ADDENDUM NO. 1

ARDOT 020673 UAPB PEDESTRIAN MALL - PHASE I

August 18, 2026

C-001

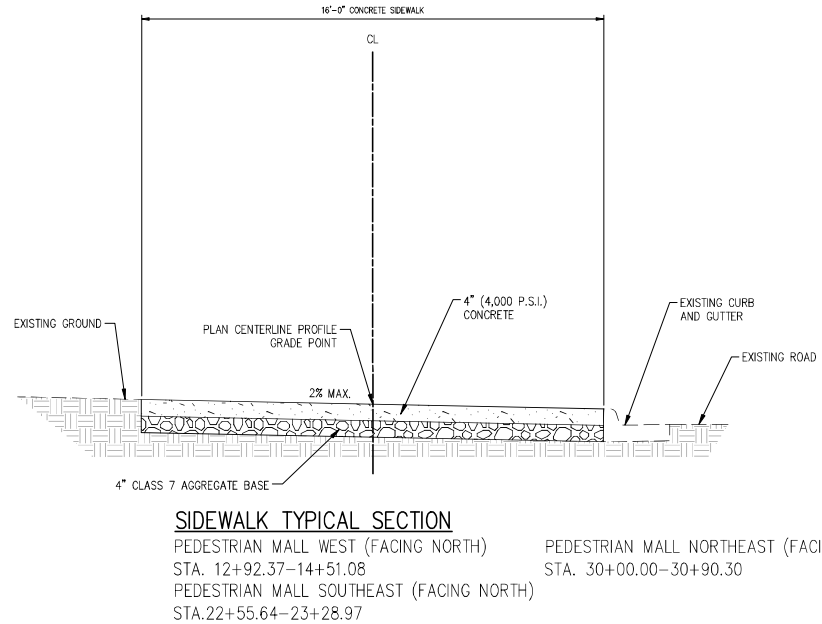
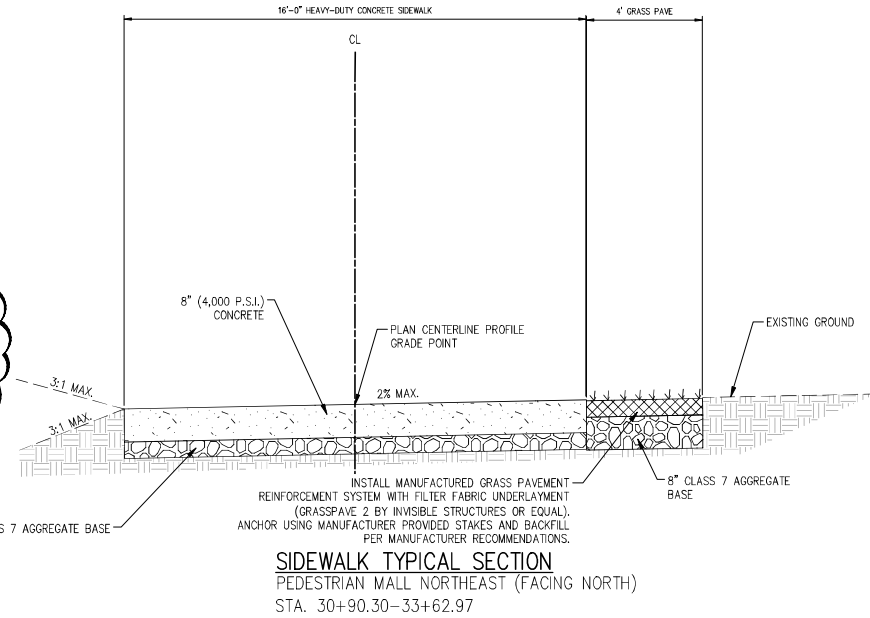
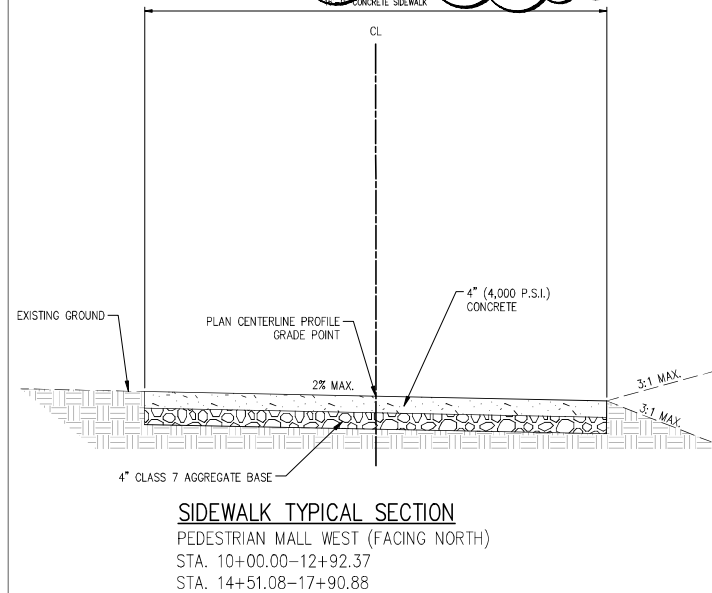
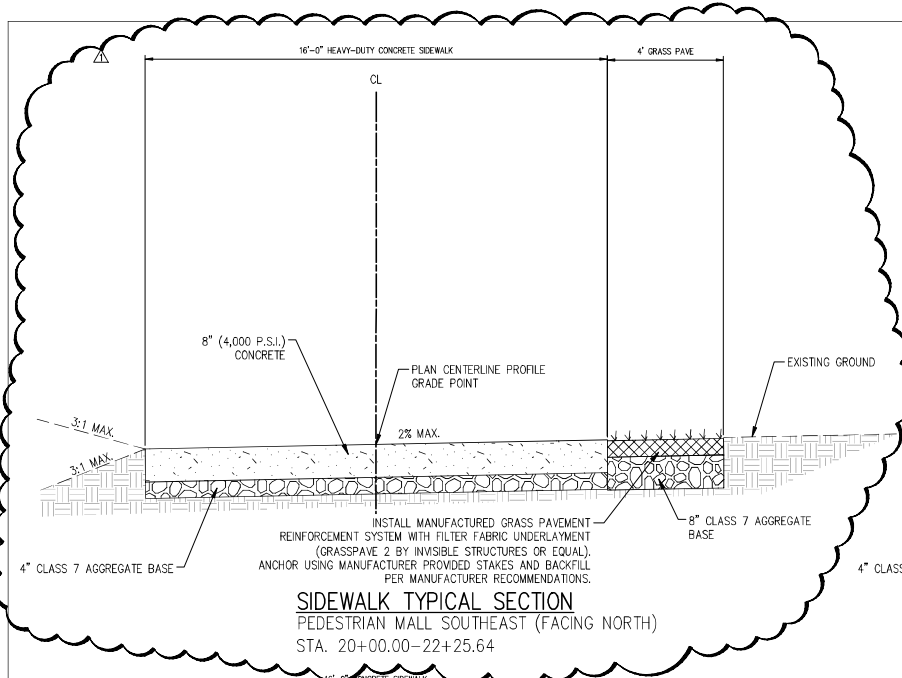
- 1. Refer to attached revised drawing SHEET C-001 for revised quantities.**
- 2. Refer to attached revised drawing SHEET C-002 for revised TYPICAL SECTION for PEDESTRIAN MALL SOUTHEAST.**
- 3. Refer to attached revised drawing SHEETS C-103 – C-105 for revised fire access routes.**
- 4. Refer to attached revised drawing SHEETS C-106 for revised fire access grades and north plaza tie-in elevations.**
- 5. Refer to attached revised drawing SHEETS C-107 & C-108 for revised limits of disturbance and erosion controls.**
- 6. Refer to attached revised drawing SHEETS C-110 for revised joint pattern.**
- 7. Refer to attached revised drawing SHEETS C-201 – C-204 for revised plan & profiles.**
- 8. Refer to attached revised drawing SHEETS C-501 for new removable bollard detail.**
